SAN FRANCISCO PLANNING DEPARTMENT

Discretionary Review Analysis

Date: January 28, 2010
Case No.: 2009.1102 D
Project Address: 736 VALENCIA STREET
Permit Application: 2009.05.20.8779
Zoning: Valencia Street NCT (Neighborhood Commercial Transit) District
55-X Height and Bulk District
Block/Lot: 3588/005
Project Sponsor: Ron Mallia
736 Valencia St LLC
810 Market Street #1128
San Francisco, CA 94102
Staff Contact: Corey Teague – (415) 575-9081
corey.teague@sfgov.org
Recommendation: **Do not take DR and approve project as proposed.**

Discretionary Review Hearing
 Case Number 2009.1102D
 Roof Deck Addition
 736 Valencia Street

PLAN - ROOF DECK
 SCALE: 1/8 INCH = 12 INCHES

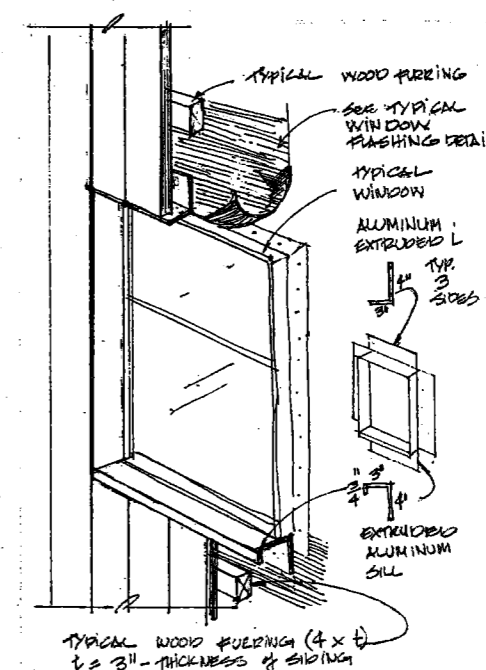
Issue 2: The proposed roof deck is very large and presents a noise problem for the surrounding residents. It is also positioned to look down into neighboring rear yards. The roof deck should be smaller, positioned toward Valencia Street, and/or provide sound reduction elements.

The original permit did not include a roof deck. The roof deck presents a noise problem for the surrounding residents. No sound reduction is present to minimize this issue.

A roof deck places a noise source at a high point from which sound will travel readily and create an excessive disturbance to the surrounding neighbors.

This roof deck is very large and can accommodate a large crowd, thereby increasing the nuisance.

The deck is positioned so as to look down into private back yards.

The deck should be eliminated or made smaller, positioned toward Valencia Street (a public street), and have sound reduction elements so as to preserve the privacy and quiet enjoyment of the surrounding back yards.

Response: The building includes a 25-foot rear setback at the second floor and above, and a front setback of 10 feet at the 5th floor. Additionally, the proposed roof deck includes a 5-foot setback on each

side. This creates a total rear setback of 30 feet and a total front setback of 15 feet to the roof deck. These setbacks help reduce potential noise or privacy issues for surrounding properties.

SOUTH ELEVATION - Roof Penthouse
 SCALE: 1/8 INCH = 12 INCHES

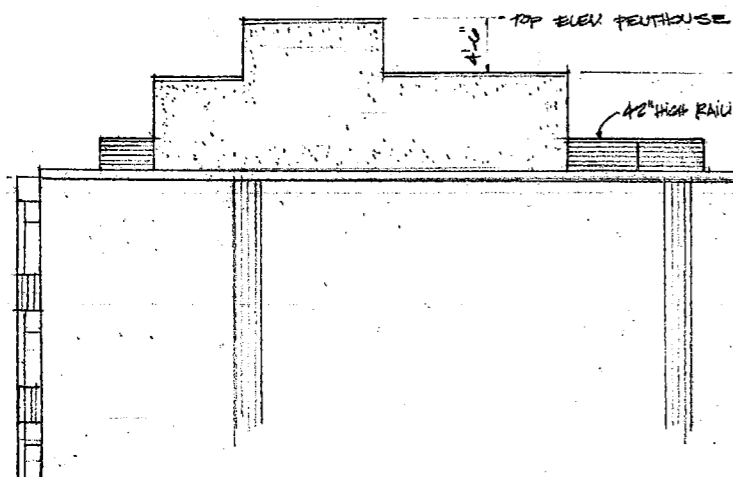
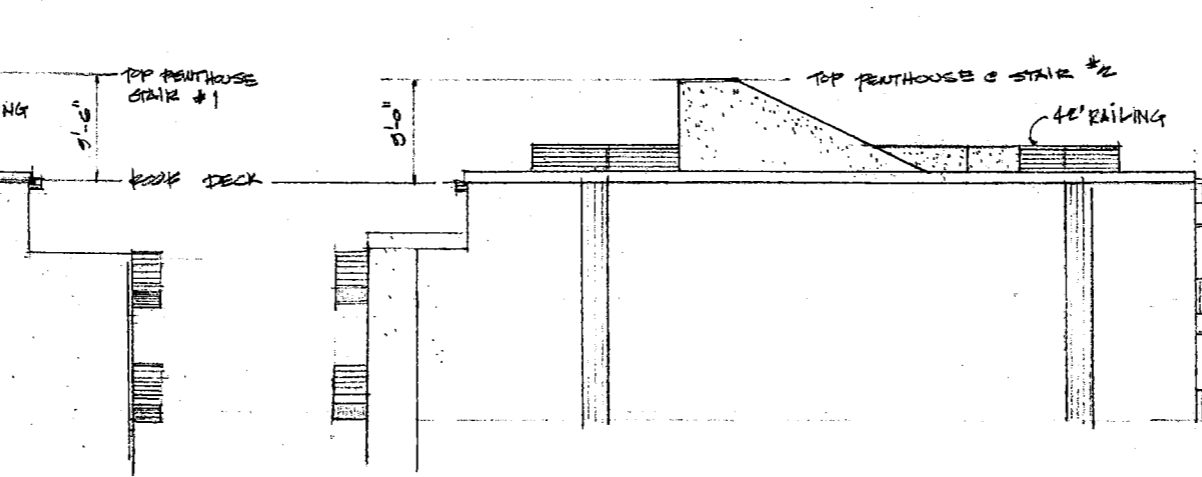
Issue 3: The DR Requestor states that the height limit must be observed.

Elevator / STAIRWAY Penthouse @ South Side of Building
Nine and one half feet taller than approved plans

Creation of STAIRWAY Doghouse on North Side of
Building Nine feet two inches above unfinished roof
Approved plans have stairway ending @ 4th floor

The height limit must be observed.

Response: The building under construction is slightly less than 50 feet in height in a 55-foot height district. The elevator penthouse could extend up to 16 feet above the roof line. However, it was proposed for 14 feet 6 inches. As part of the work referenced in DBI's Notice of Violation, the sponsor actually constructed the elevator penthouse to 16 feet above the roofline. The penthouse will be revised to only extend 14 feet 6 inches, as it was noticed.

- Downsize the elevator penthouse from a height of 16' 6" down to 14' 6" above the roof deck, which is the minimum height per the California Building Code
- Place noise guidelines in the building's Rules for Enjoyable Living
- Provide neighbors with the building owner's direct telephone numbers to expeditiously address complaints
